## 2. Analysis

### 2) Review operation by BOOST IC MAKER

#### ① PBAFA1454A - Revision A

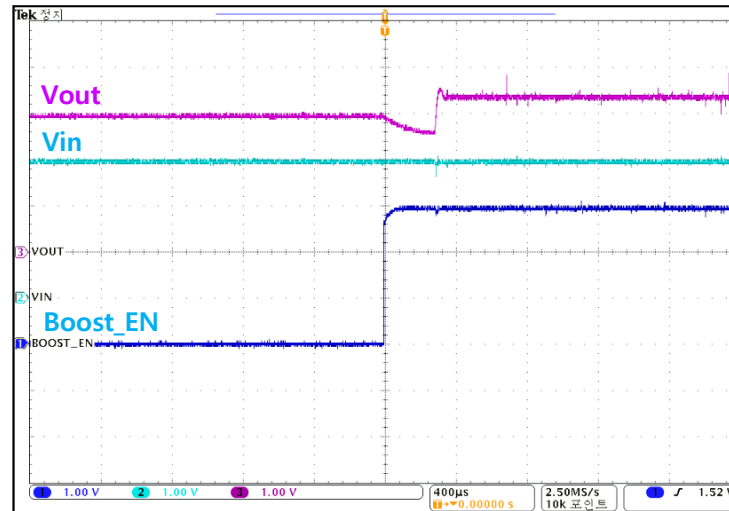
IMS (IM8132S) : Vout 3.3V Normal Output

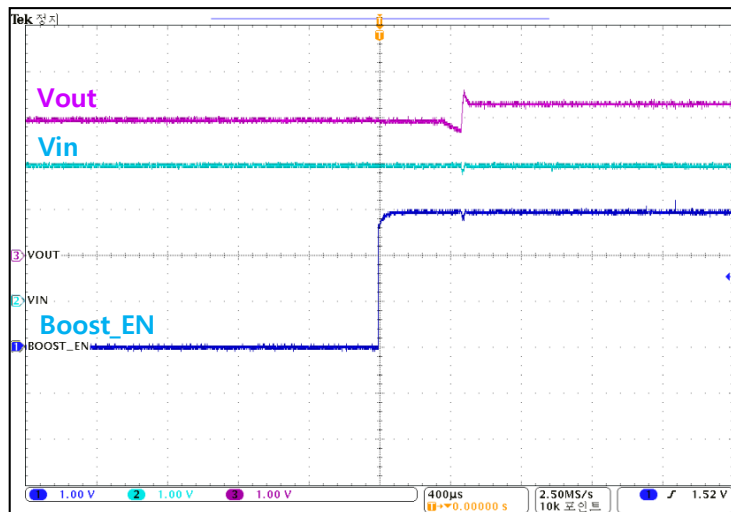
TI (TPS61097A) : Vout 3.3V Normal Output

#### ② PBAFA1454B - Revision B

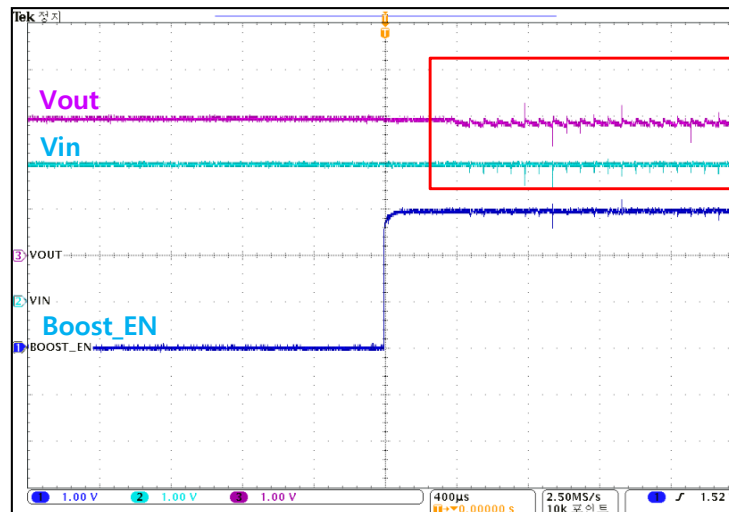
TI (TPS61097A) : Vout 3.3V not output, Vin voltage bypass output.

- Pull-down Resistance (R23) 100K -> Change to 1 Mohm & Remove : No Vout Improvement
- Voltage distribution by adding 100K as Serial to Boost\_EN line: No Vout improvement

#### 2) GND : Connecting GND to (-) terminal Direct : No Vout improvement

- Remove FET (Q1,Q2) and connect with 0 ohm resistance between D-S to connect with GND and (-) terminal Direct - (-) terminal PAD to some copper plates

#### 3) Power engineer (L2) 4.7uH -> 10uH: No Vout improvement

#### 4) Changing the C18, C19 correction number of Boost IC's Vin/Vout: No Vout improvement

- C18,C19 : 10uF -> 1uF : Vout voltage down
- C18,C19 : 10uF -> 22uF : Vout voltage slightly increased (0.02V increase)
